ADDENDUM NUMBER 04

09-54

PSU Business Accelerator Wet Lab Tenant Improvements ("Wet Lab TI Project")

# AA-14

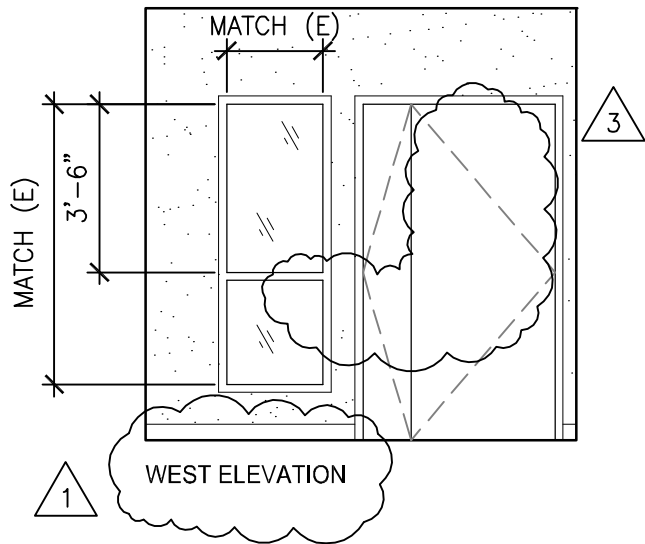
A7.02 Interior Elevations  
1/A7.02 HALL H211A

Revise door elevation. See attached drawing AA-14.

**Question #3** Door schedule for door H211A calls for door type B but elevations show door type C. The window and glazing at this door will need to be rated.

PDC Response: The Door Schedule is correct. Door H211A should be Door Type B. The West Elevation for Hall 211A has been revised in Addendum #4.
